DSBC-...-D3: Profile Cylinder DSBC with sensor slots on 3 sides
Introduction of product changes

ECN No
256 417

Project Title
Change of DSBC-...-D3

1. Previous Version

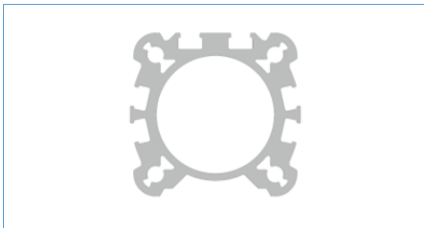
Profile design with tangentially arranged sensor slots on the left/right side

1. Future Version

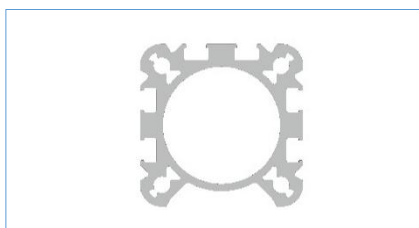
Profile design with parallel sensor slots on all three sides

2. Previous Version

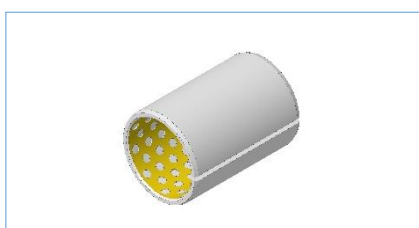
Bearing made of POM

Bearing made of composite materials steel, sintered bronze and POM coating

3. Previous Version

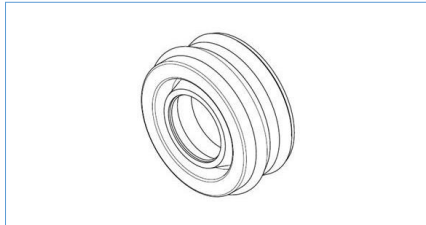
Wiper seal made of TPE-U

Two-component wiper-seal made of TPE-U and TPE-E
